UNITED STATES PATENT AND TRADEMARK OFFICE

APPLICATION NO.	FILING DATE	FIRST NAMED INVENTOR	ATTORNEY DOCKET NO.	CONFIRMATION NO.
10/691,318	10/22/2003	David M. Shamine	03-274	2187

Office Action Summary

DETAILED ACTION

FIG. 15

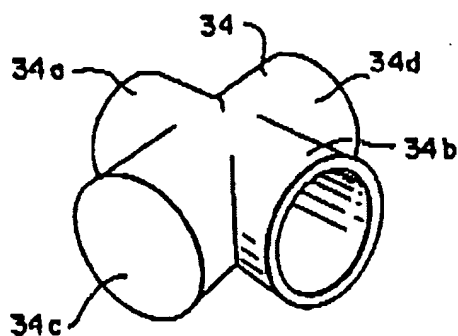
suggests at least three fuel spaces. Greco et al. explicitly disclose a first leak (45) line coming from the fuel rail (28). Greco et al., discloses more than one common rail (Col. 4, lines 40-44), which suggests at least a second common rail. Combined with the disclosure to provide for more than one leak line from different high pressure spaces (Col. 4 line 58 to Col. 5, line 12) this teaches at least two rail lines connected to a wet sensor (38). Greco et al. further discloses provide a leak line from the high pressure pump (Col. 5, lines 5-9) to the wet sensor (38). In summation Greco et al. suggests a leak detection system with at least three leak lines and one wet detector; two leak lines from the two common rails and a third from the high pressure pump. Greco et al. do not explicitly disclose the structure for connecting three leak lines to one wet sensor. One of ordinary skill in the art would have two ways to connect the three lines to one output, either the leak lines would either lead into a common line at different points or there would be a junction at which all the leak lines would converge. Fig. 15 (below) illustrates a junction for connecting three inputs (leak lines) to one output (wet sensor).

26. It would have been obvious to one of ordinary skill in the art at the time of the invention to modify the system disclosed by Greco et al. by providing a connection with three inputs and one output, as disclosed by Fig. 15, in order to save the expense of providing additional wet sensors.

27. With respect to claim 1, the combination as provided above discloses a leak diagnosis component for the fuel system of an engine (Col. 4, line 58 to Col. 5, line 12). The junction described in Fig. 15 above is considered to be a "junction block" with a plurality of inlets (34a, 34b 34c) and at least one outlet (34d). The combination described above teaches connecting the inlets of the junction to the leak lines of a fuel system of an engine ((Col. 4, line 58 to Col. 5, line 12). The cavity is considered to be the empty space inside the junction. The leak diagnostic port is considered to be the each of inlets 34a, 34b, 34c which are located between the interior cavity and the external surface of the junction.

29. With respect to claim 4, the combination as applied to claim 1 discloses the outlet being a single outlet (34d, Fig 15 above).
